**From:** Ethan Martin [martin.e@minutemanintl.com]  
**Sent:** Wednesday, June 12, 2013 10:05 AM  
**To:** 'Angie Brown'; 'Greg Fisher'; 'Donna Garner'  
**Cc:** thompson.g@minutemanintl.com  
**Subject:** RE: LP TANK WILL NOT FIT

MODEL: WC-09 HAKOMATIC  
DOCUMENTED BY: John Mye  
PAGE NUMBER: 54  
DATE: 11/21/08

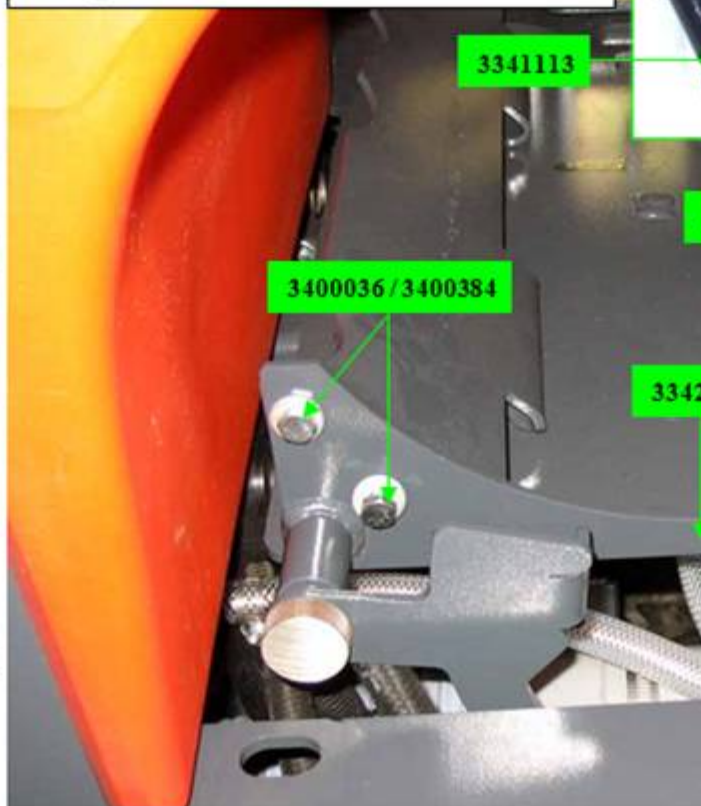
I know it's early, but do you have an answer to this? Part I understand to reverse the rear plate and remove the block, but what about the door thing?

I'm beginning to wonder if the door was never there on the original "War Pony" "5550" and it was only added for Hako and the 1800. And it was just a pin that kept the bottle from sliding out.

Greg  
Talking to my LP tank vendor all 33lb LP tanks from all manufactures are the same in length . To buy one that would fit in the LP compartment as it is would be a 20 lb LP tank. Which I have been dealing with the customer That we will be delivering this unit to and he will go thur the roof and will be calling every one and their brother.  
You can forward this message as well so they can get ready for the calls too.

Please see the work instructions below. The rear plate does not need to be flipped. The silver block and anti-rotate device in the rear do need to be removed, but the dark grey plate they are mounted to stays as is.

Get (1) WELD-CLAMP LPG MNT. (3342733), (1) WELD-LPG MNT FRT (3342732), (1) SPACER-LPG CAGE (3341113) and (1) CLAMP SCREW-LPG (3341116) and assemble as shown at right.

Close valve on LP tank. Disconnect LP tank hose from LP tank and remove LP tank from unit.

Place assembly on end of ASSY-LPG TAN in WELD-LPG MNT FRT with holes in CRADDLE. Get (4) SCR-HEX, 5/16-18x WASHER-CONICAL SPRING 5/16 (340 insert though (4) holes, (2) on each side of into (4) weld-nuts on end of ASSY-LPG T Tighten. Replace LP tank in compartment
